Subject: CHECK ENGINE LIGHT ON WITH P0451:00 IN COLD WEATHER	Bulletin No: 01-003/17
	Last Issued: 01/20/2017

2014-2016 Mazda3 vehicles with VINs starting with JM1

2014-2016 Mazda3 vehicles with VINs starting with 3MZ

For 5-door hatchback

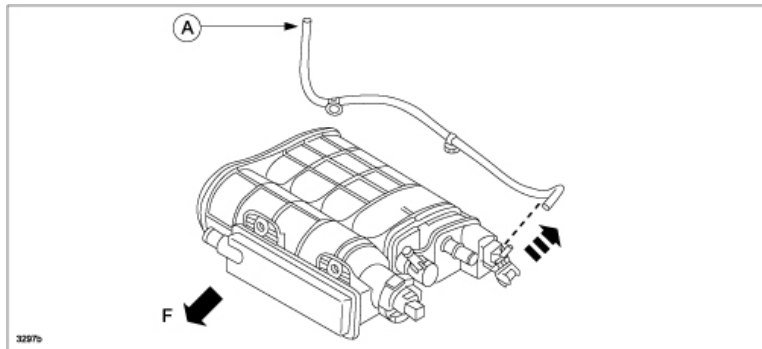
- a. Pull out the Evaporative Hose No.1 (A) from the Charcoal Canister outlet.

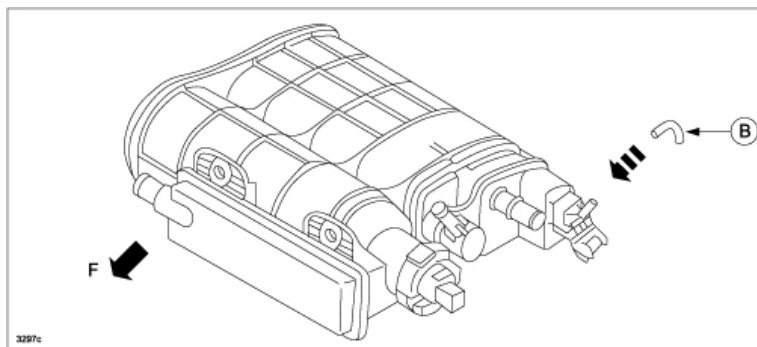
- b. Install the Canister Hose (PE01-13-971) (B) to the Charcoal Canister outlet.

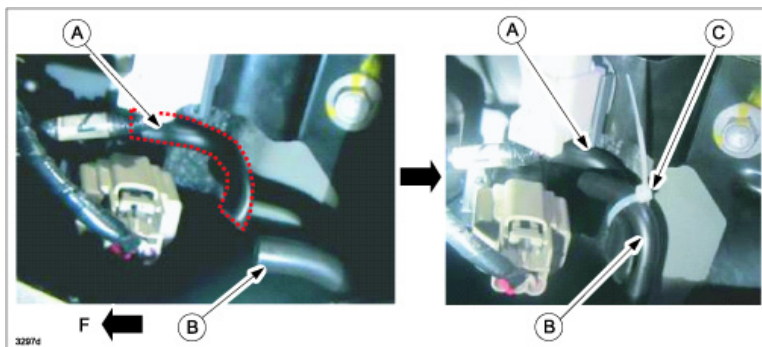
- c. Tie the Evaporative Hose No.1 (A) and the Canister Hose (PE01-13-971) (B) with a tie-wrap (C) as shown.
